**POST BID ADDENDUM NO. 03
LEGRANDE ELEMENTARY SCHOOL ADDITION AND RENOVATION
SCB PROJECT NO. 2210**

FROM: Sherman Carter Barnhart Architects
144 Turner Commons Drive, Suite 110
Lexington, Kentucky 40508

DATE: September 11, 2023

This Addendum consists of 50 pages / drawings.

2 SITE UTILITY PLAN – PLUMBING
NO SCALE

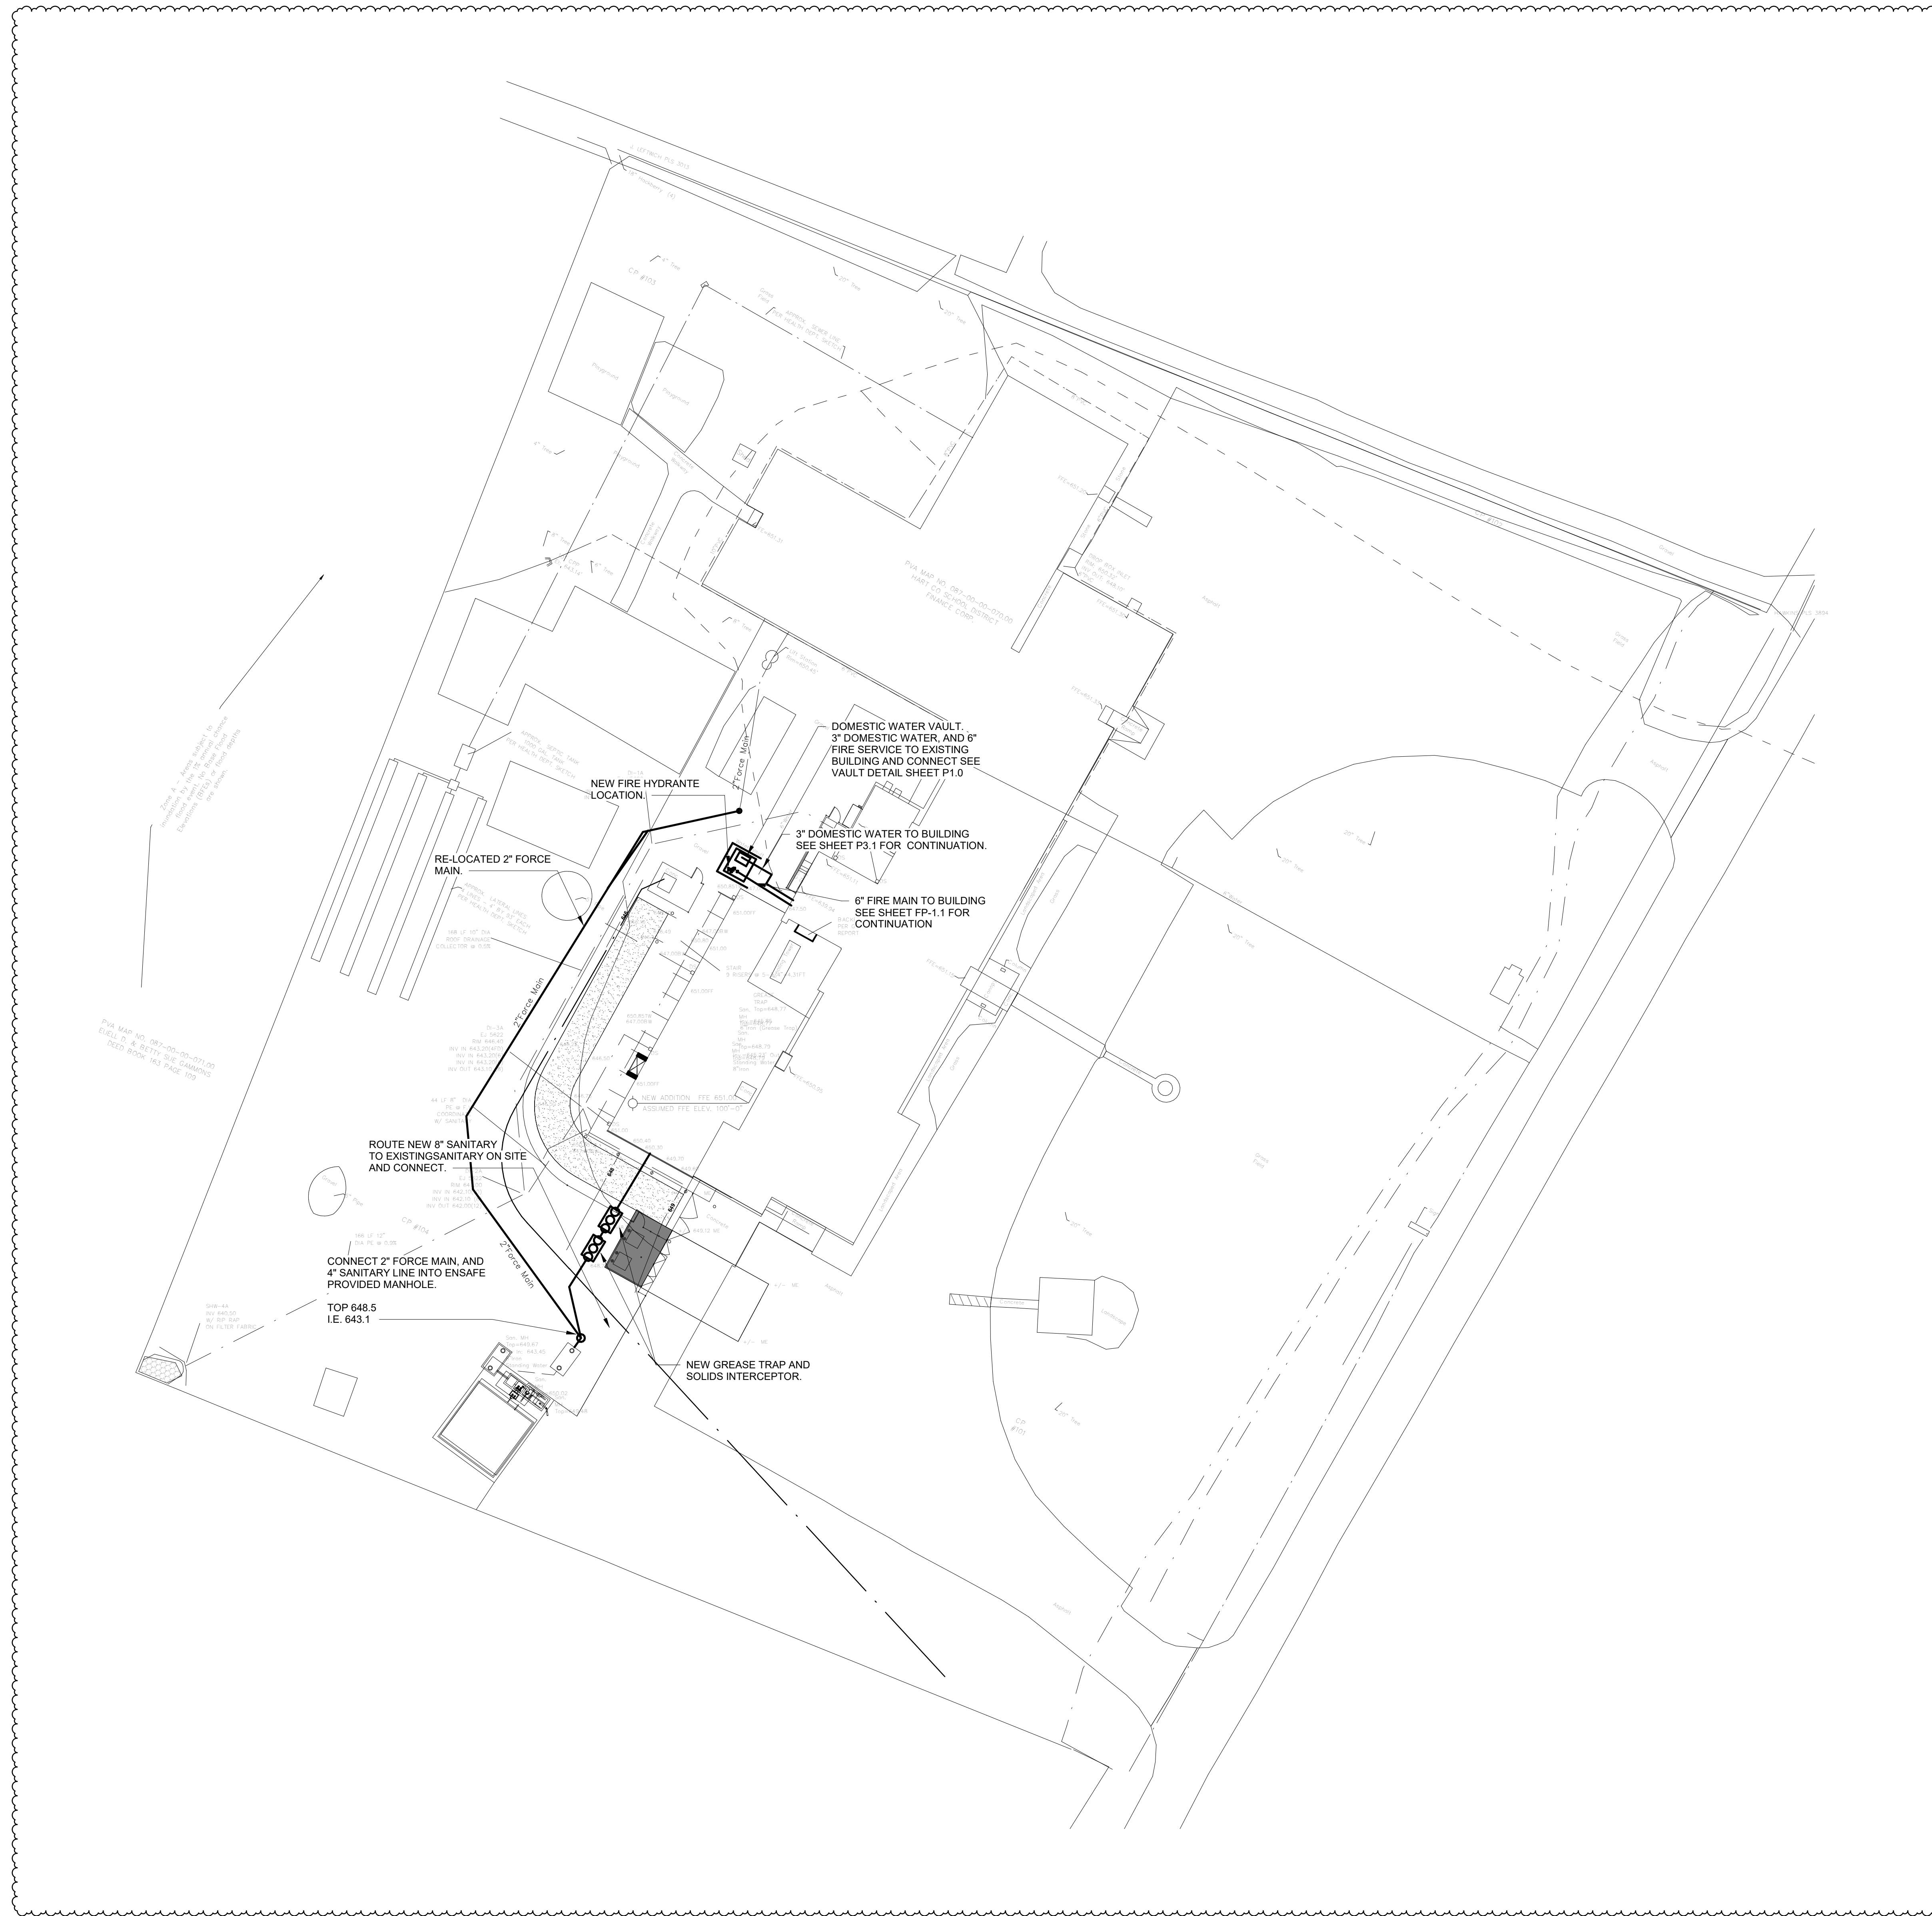
8. Sheet P4.1 – SITE UTILITY PLAN – PLUMBING
 - a. Reworked all site utility lines.
Add or Deduct: \$_____.

1 WASTE AND VENT RISER DIAGRAM
NO SCALE

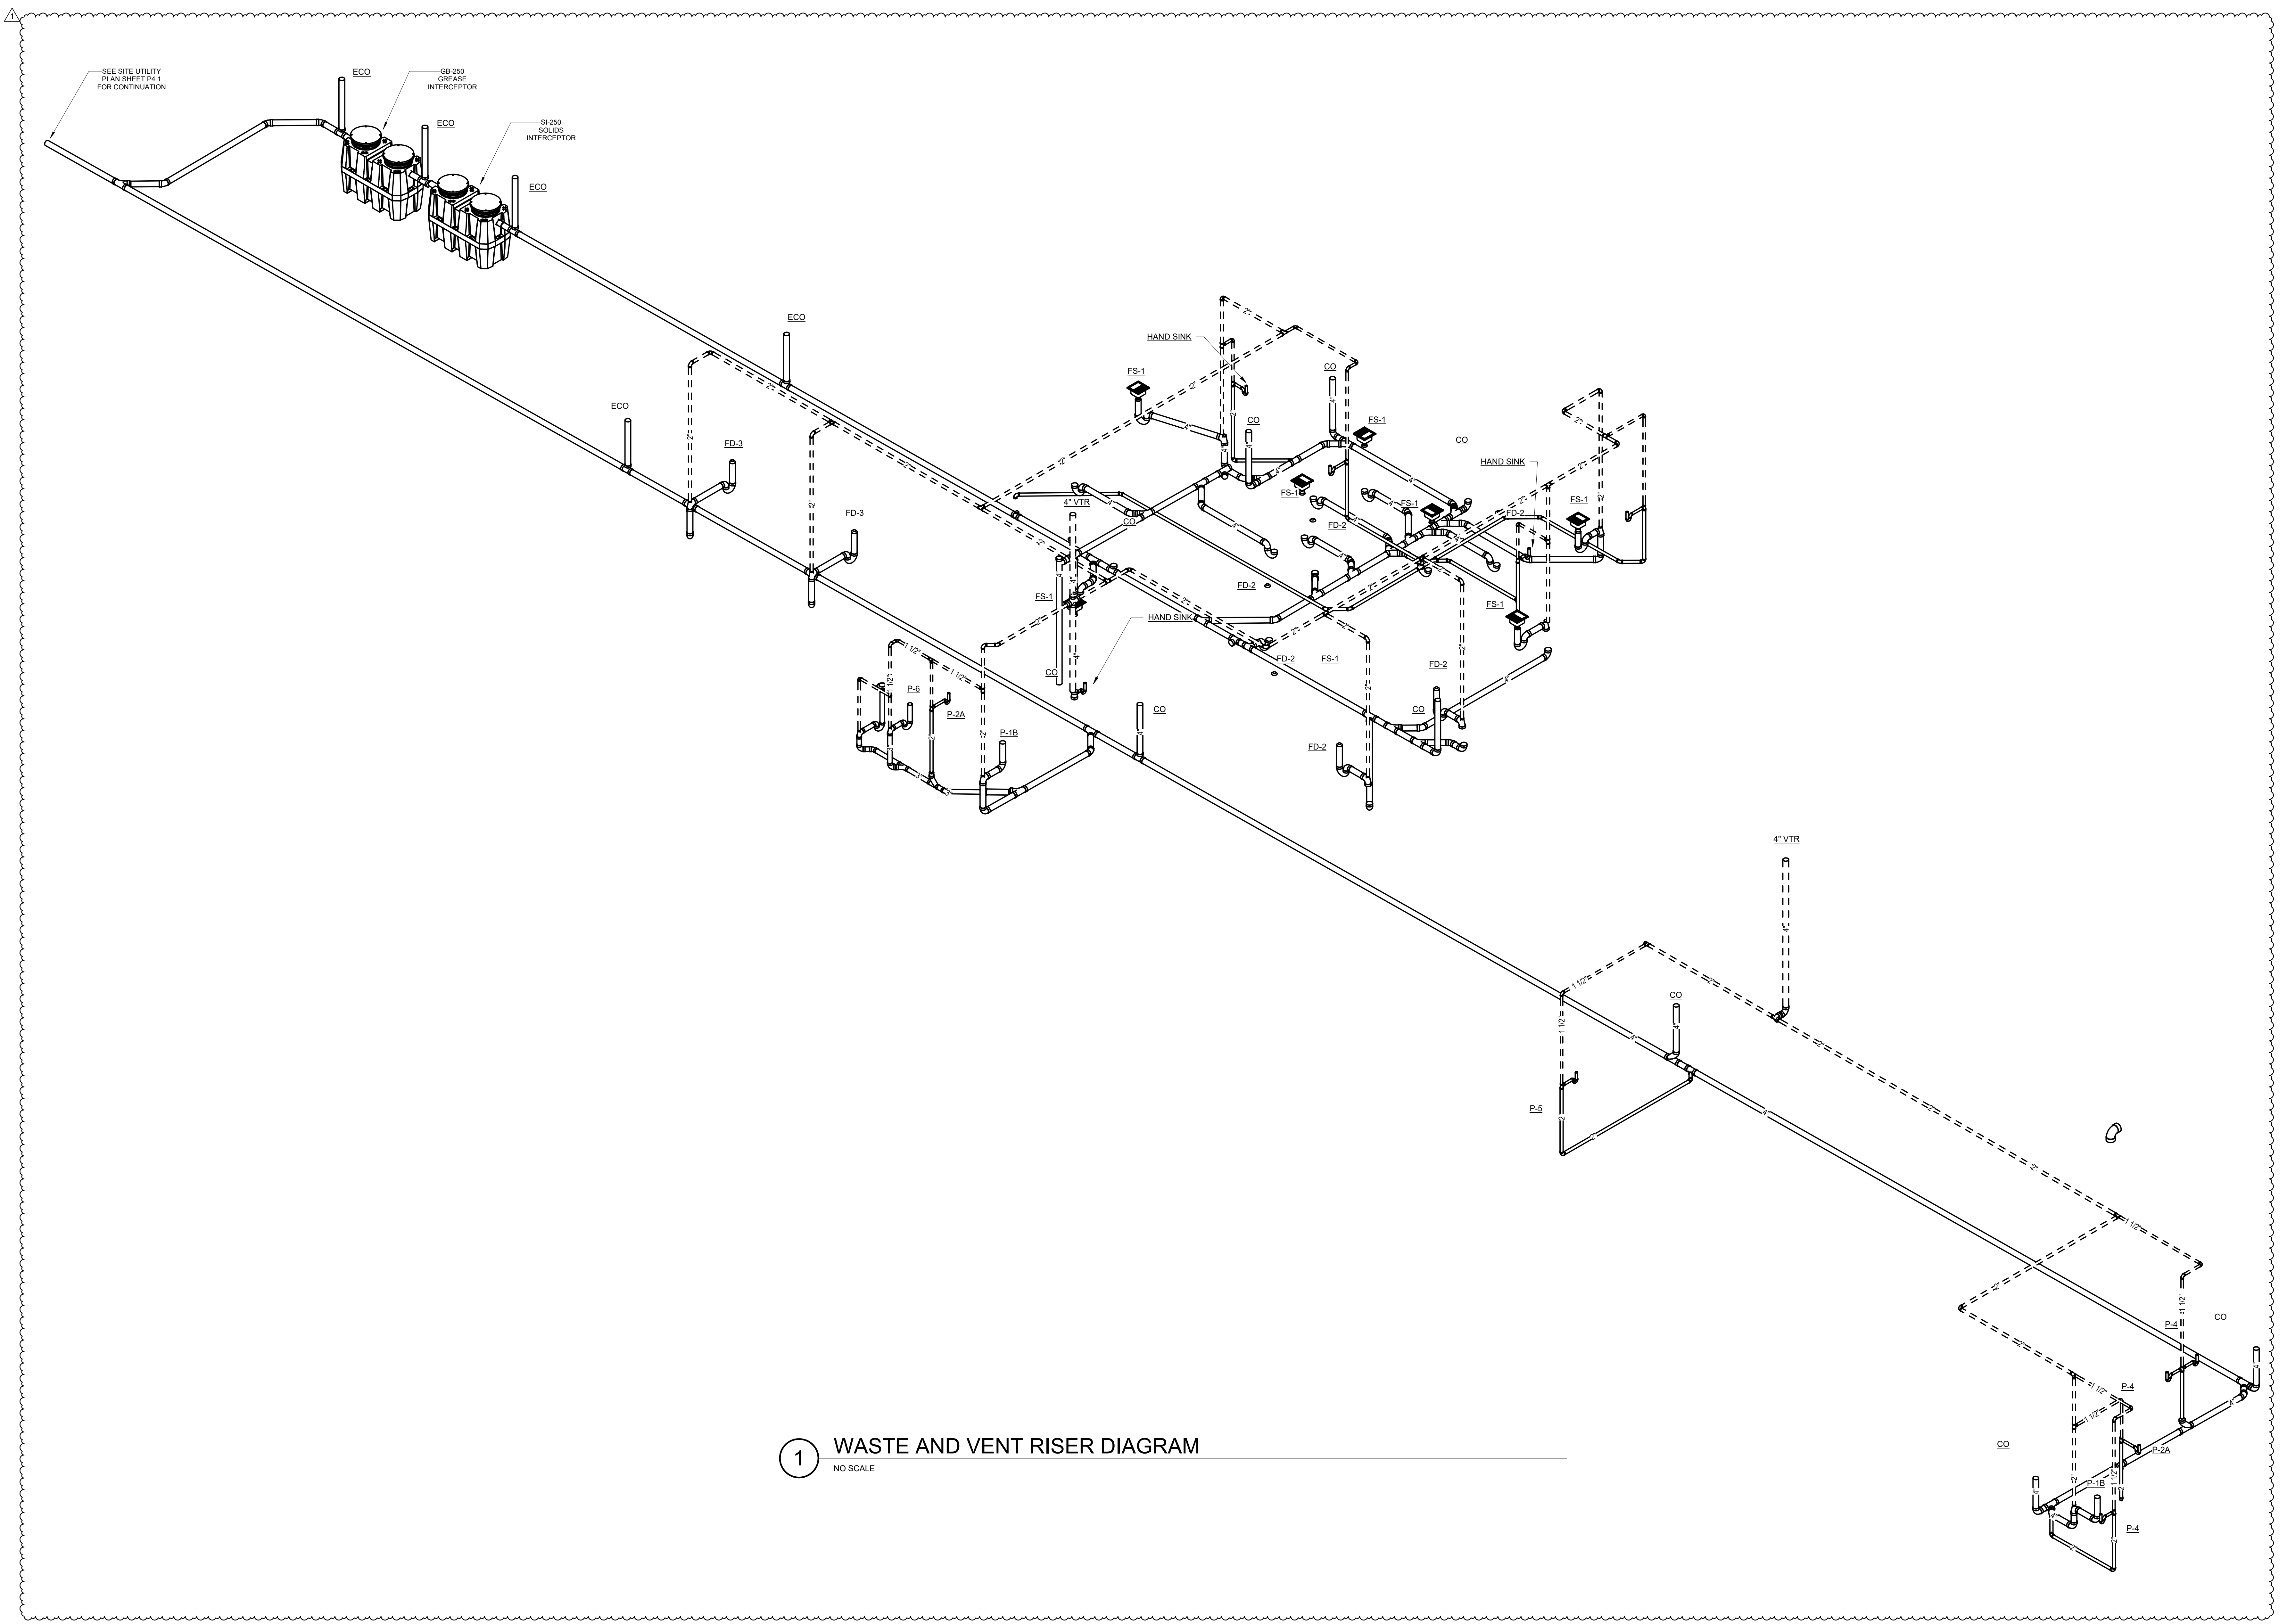
9. Sheet P5.1 – WASTE AND VENT RISER DIAGRAM
 - a. Riser to change to reflect grease trap changes.
Add or Deduct: \$_____.

1 MECHANICAL ZONING PLAN
SCALE: 1/8" = 1'-0"

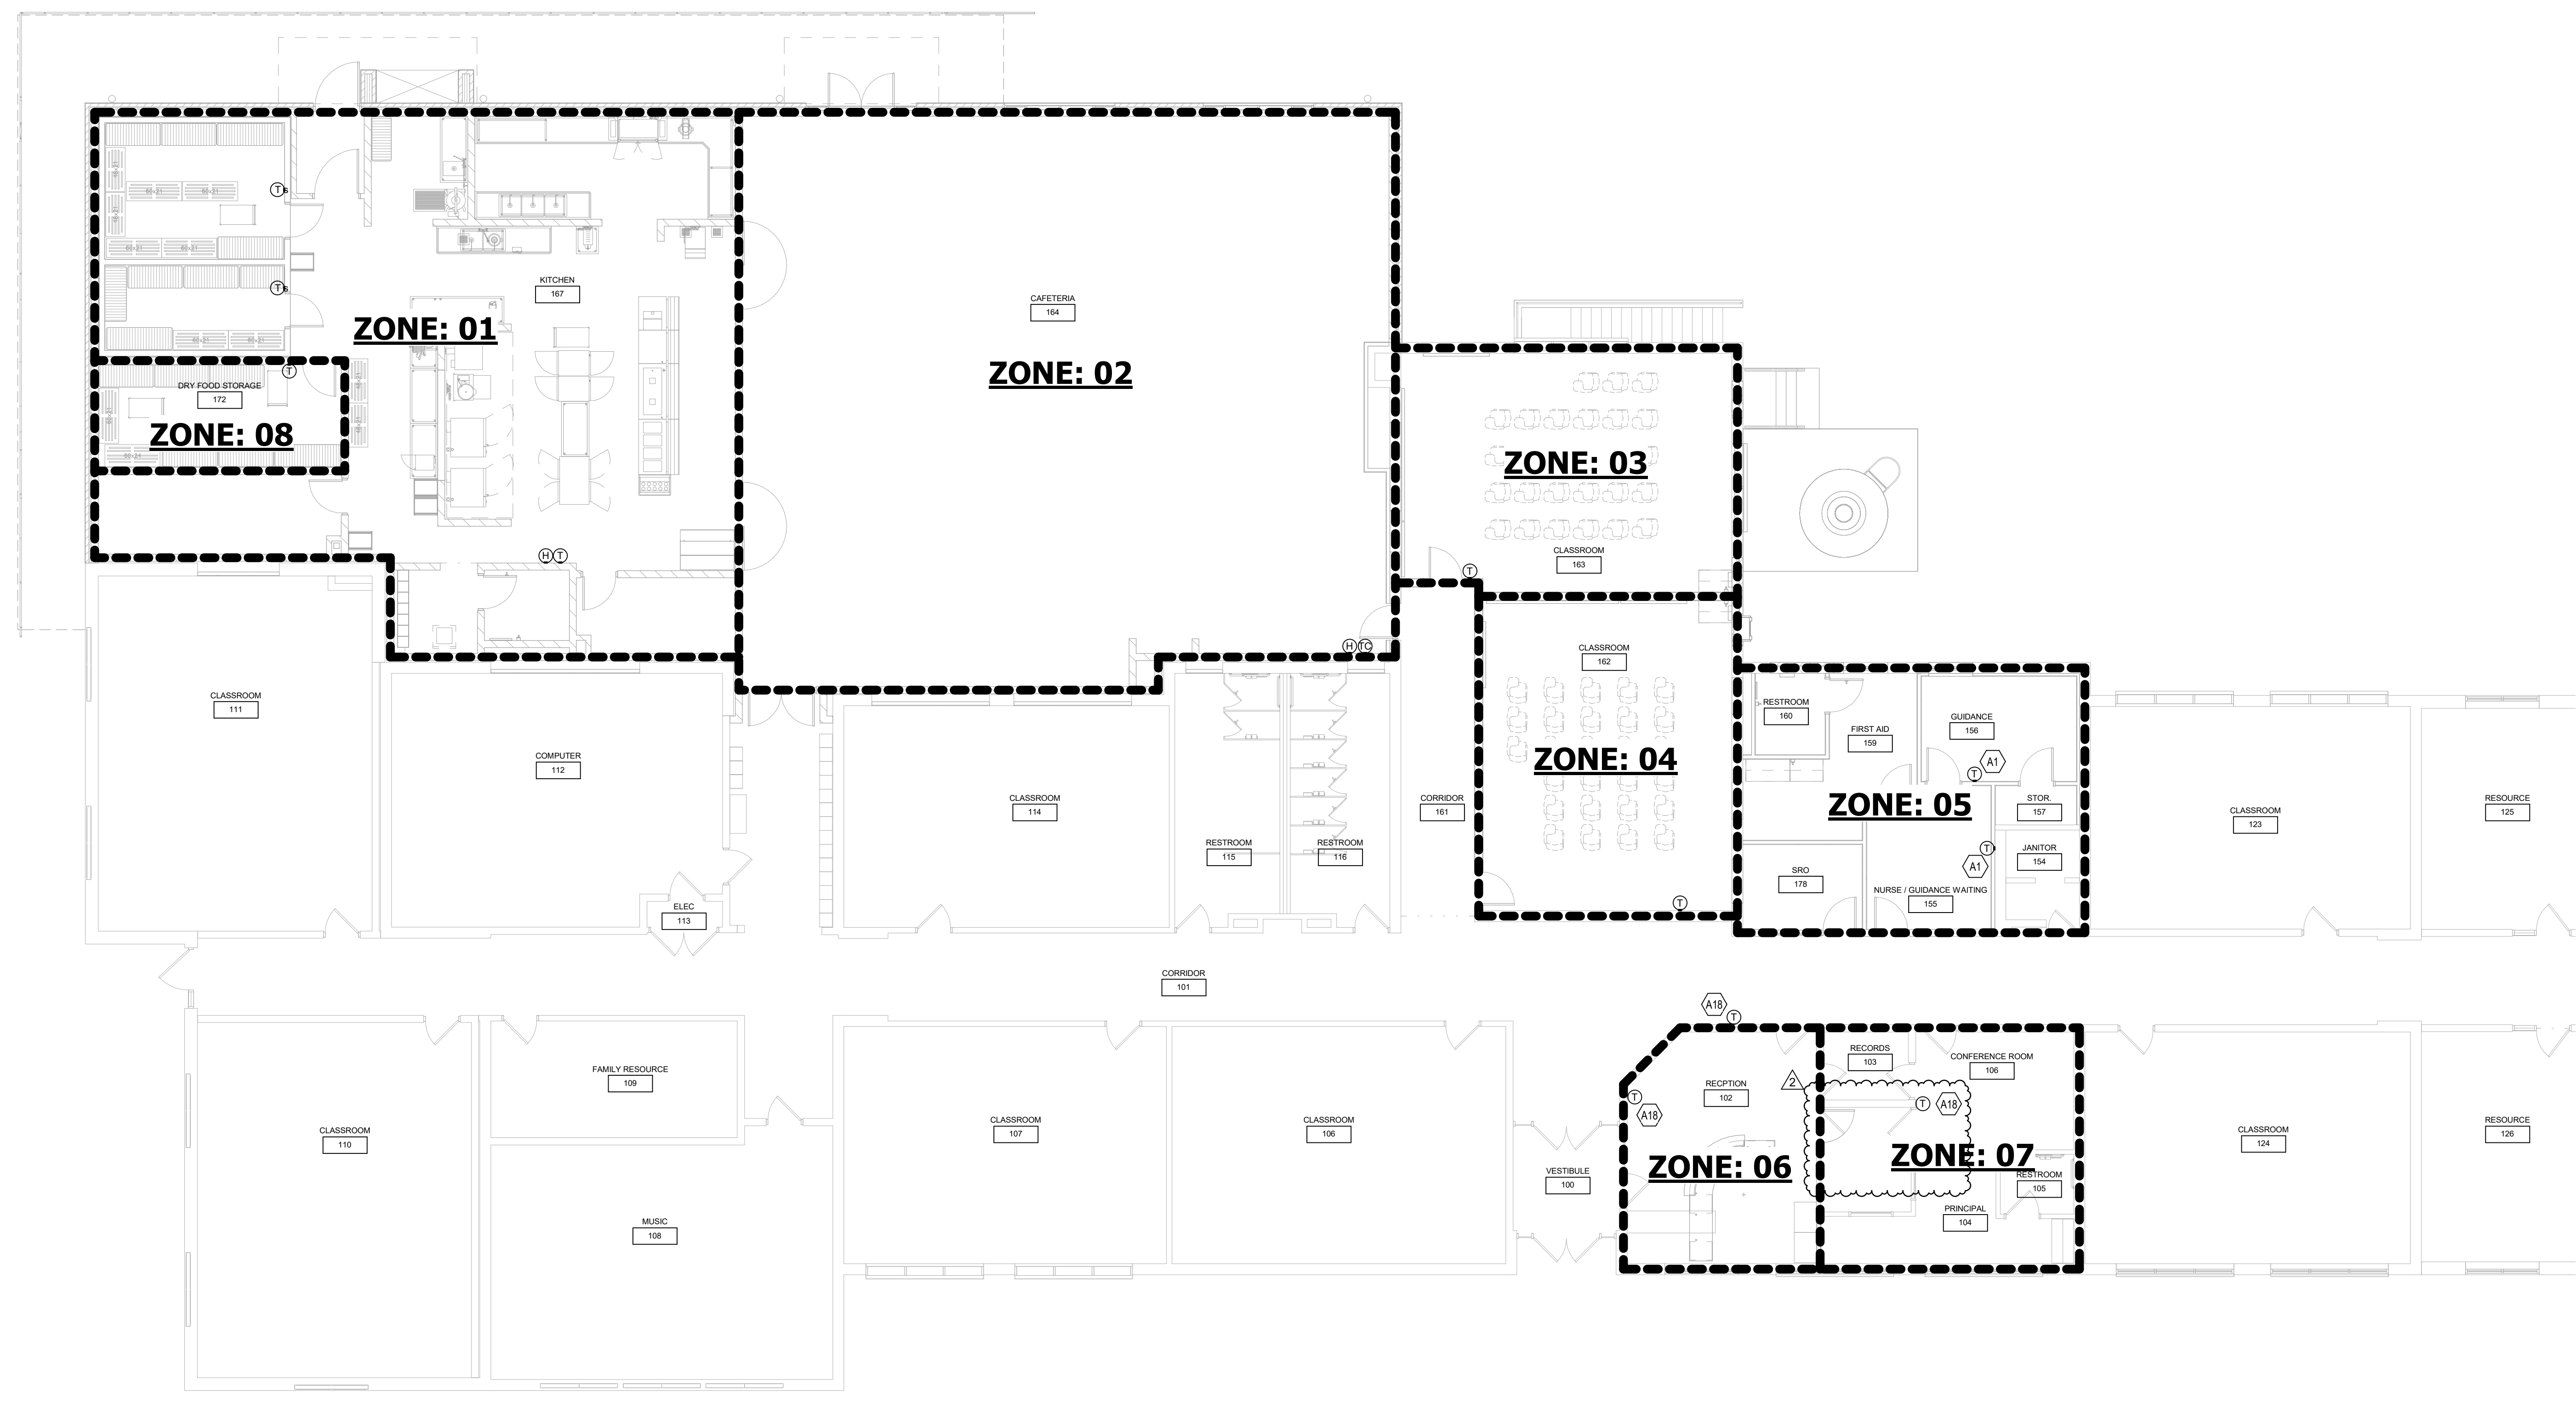
1. Sheet M1.1 – Mechanical Zoning Plan
 - a. Revised Keynote in existing admin area to remove from scope of work.
Add or Deduct: \$_____.
